### ADDENDUM NO. ONE

Replace Exterior Entrance Doors for  
Roger B. Wilson Government Center Building  
801 E. Walnut St.  
Columbia, MO 65201  
Bid Number 15-23 MAR16

Bid No. 15-23MAR16  
Replace Exterior Entrance Doors for  
Roger B. Wilson Boone County Government Center Building  
801 E. Walnut St.  
Columbia, MO 65201-7732

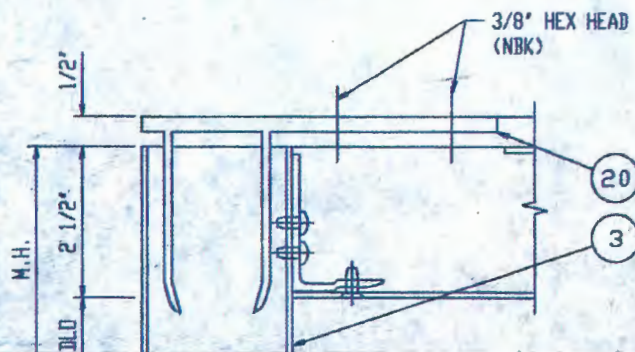
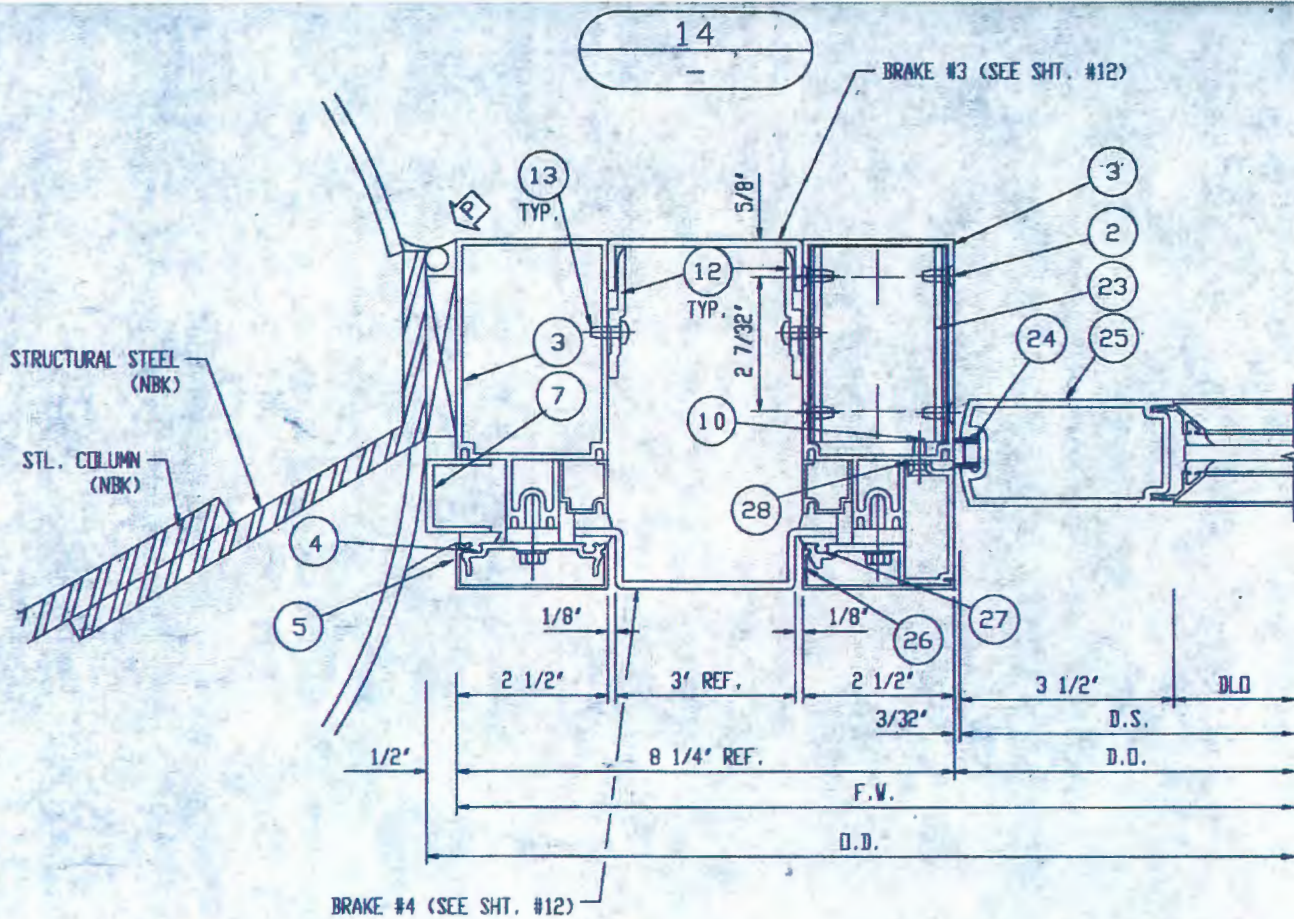
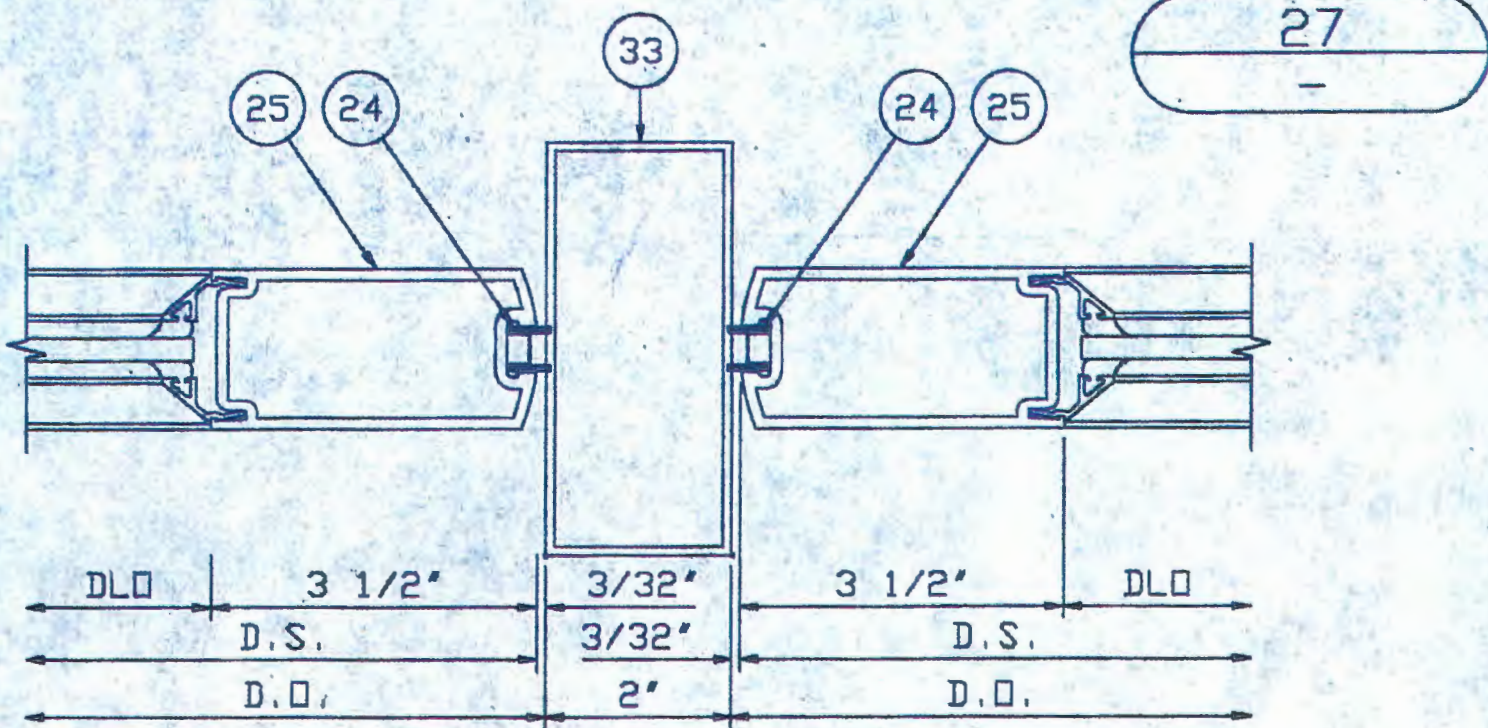
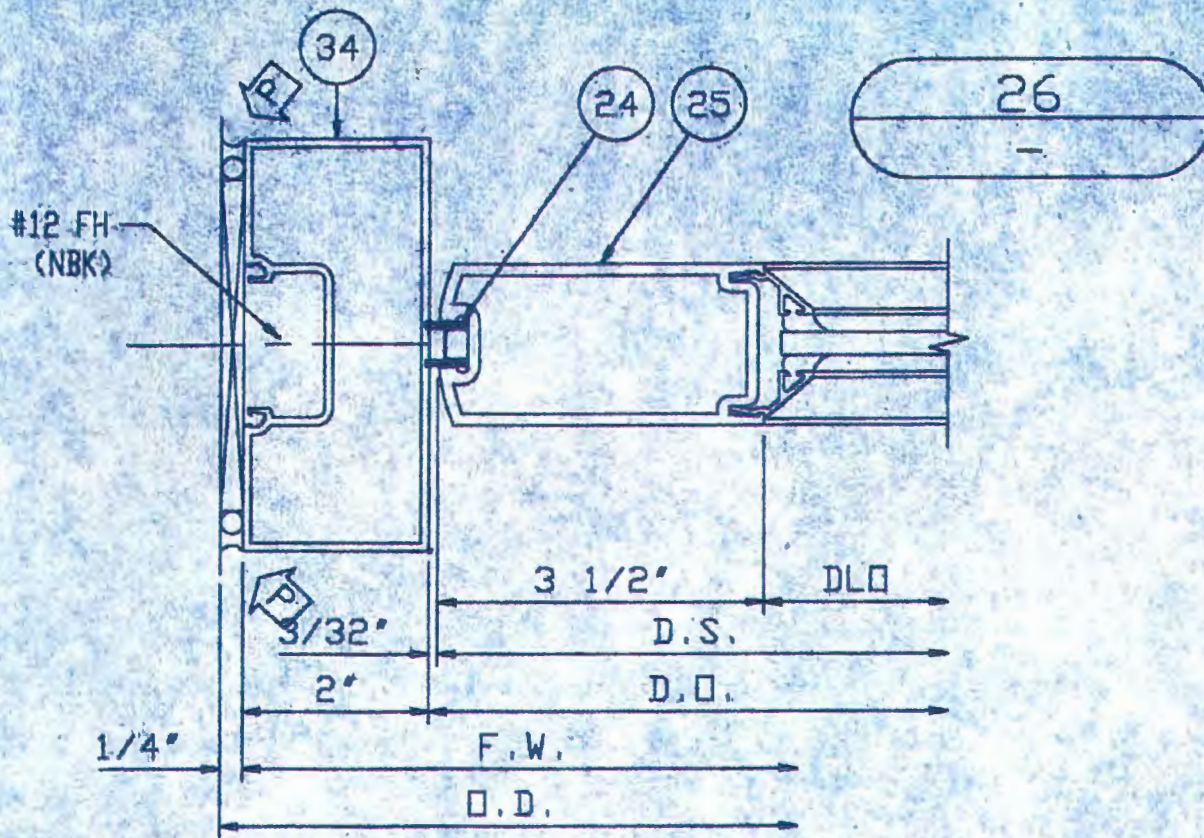
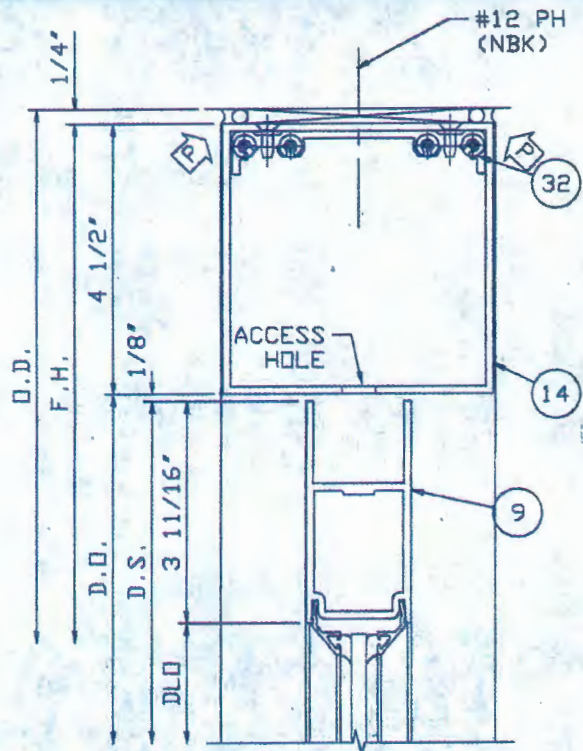
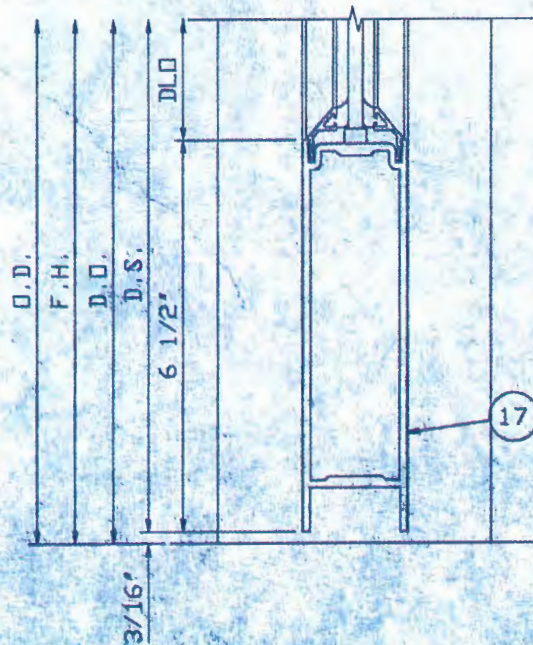
6. Drawings, Sheet 6, Vertical and Horizontal Sections, Details A/6 thru D/6.  
Clarification: "Doors No. 1, 2, 3 & 4 - contractor shall remove and replace existing framing at existing jamb & head and install new 6" curtain wall framing with new 4-1/2" sub-frames immediately surrounding the new doors. Accordingly, aluminum entrance doors shall be custom sized to fit the width and height of the new frame sizes. For the contractor's use are attached existing drawings for the existing jamb and head condition from the original shop drawings. Kynar paint finish shall be custom matched to adjacent existing door frames."
